APPLICATION NO.	FILING DATE	FIRST NAMED INVENTOR	ATTORNEY DOCKET NO.	CONFIRMATION NO.
10/523,319	01/31/2005	Yasuo Ohama	52201-0632	7665

Office Action Summary	Application No. 10/523,319	Applicant(s) OHAMA ET AL.	
	Examiner JASON L. LAZORCIK	Art Unit 1791

DETAILED ACTION

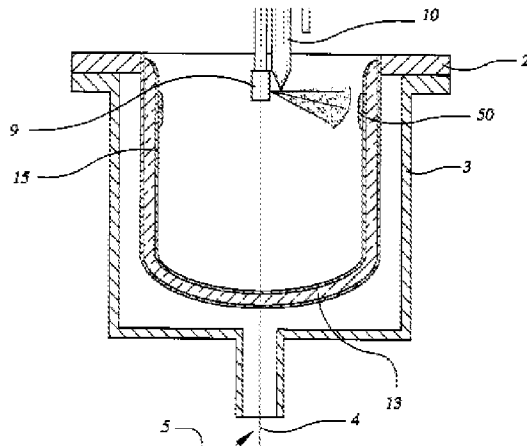
14. With particular reference to the instant figure 5 (see excerpt below), Fabian teaches a crucible base body (13) having a bottom part having a lowest side and a side wall having an upper end plane. An inner layer (15) made of a synthetic quartz extends from the bottom to a height of $1.0 H$. A roughened surface (50) is provided in the upper third of the crucible (col. 5, lines 40-45) which effectively subdivides the inner layer into 1) a first part of inner layer (15) made of synthetic quartz and extending from the bottom to at least a height of $0.25 H$ and up to the roughened surface, 2) a second part provided in the upper third (e.g. approximately $0.66H$ to approximately $1.0H$), and a residual part (15) made of synthetic quartz and located between the upper terminus of the roughened surface (50) and the upper end plane of the base body (13). Regarding

claims 3 and 4, the Fabian teaches that the synthetic layer (15) (col. 5, lines 29-34) and the roughened portion (50) (col. 7, lines 53-57) are both about 2.5 mm thick and that the roughened surface (50) may be formed upon or instead of the synthetic silica layer (15) (col. 7, lines 55-57).

17. It is evident from the foregoing that Fabian teaches providing a high bubble content inner layer in the approximate region (e.g. $\sim 0.66H$ to $\sim 1.0H$) which overlaps the "second part" presently claimed by Applicant (e.g. $\sim 0.5H$ to $\sim 0.8H$). Fabian teaches a preferred embodiment wherein the roughened surface (50) is fabricated from a mixture of synthetic SiO_2 granulate and a trace amount of gas forming compound.
